Technical Bulletin

Bulletin No.: PRO-03-25 Effective Date: 4/15/84 Page: 1 of 2

Subject: E-10 Brake Valve #101270 Modification Kit #265073

FIGURE 1

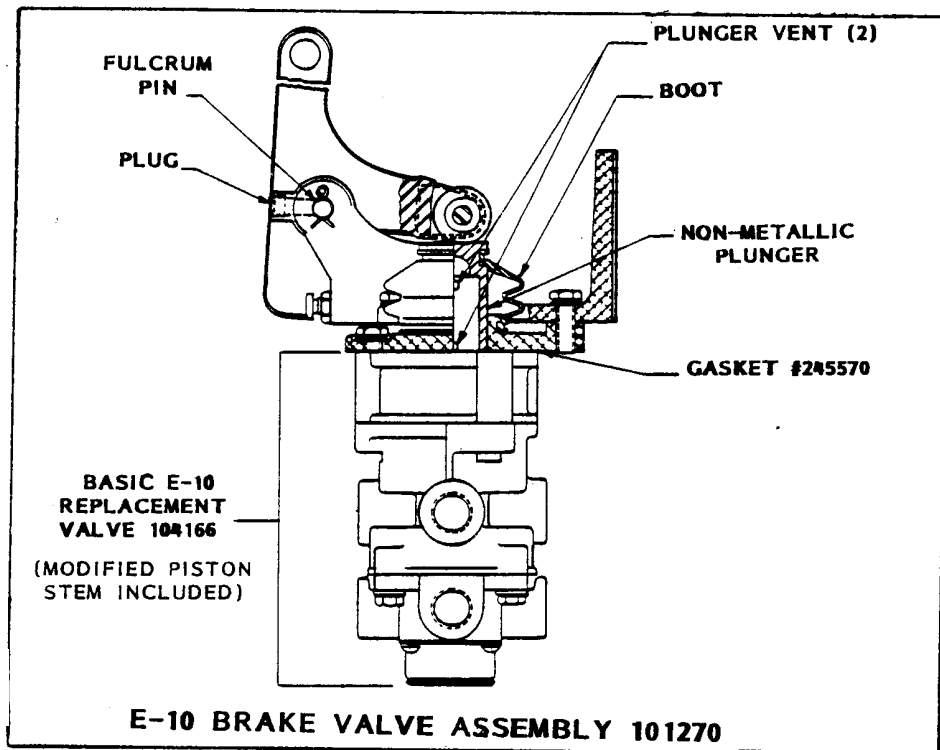
It has come to our attention that the remote mounted E-10 Brake Valve assembly 101270 as installed on M.C.I. and T.M.C. coaches is more susceptible to contamination and internal corrosion due to one or more of the following;

1. Plunger boot deterioration and wear caused by over lubrication of the actuator mechanism.
2. Insufficient sealing between the plunger, boot and mounting plate as well as between the mounting plate and valve body.
3. Contamination entering the brake valve (primarily water and road salt) due to the pumping action of the plunger and boot during application and release.

A number of changes have been made to assembly 101270 to improve its resistance to contamination and internal corrosion on the M.C.I. and T.M.C. installation. (Reference Figure 1)

1. A stainless steel fulcrum pin replaces the standard pin. Factory lubrication of the bell crank and mounting bracket assembly permits the removal of the bell crank grease fitting and eliminates the need for periodic lubrication.
2. A bellows type boot replaces the standard E-10 boot. The bellows boot reduces chaffing and provides improved sealing between the plunger and mounting plate. The addition of a gasket (245570) between the valve body and mounting plate further improves overall valve sealing.
3. A special non-metallic internally vented plunger and a modified primary piston stem permits venting of the boot cavity into the brake valve exhaust. The piston and boot cavities are maintained at or very near atmospheric pressure eliminating the pumping action.
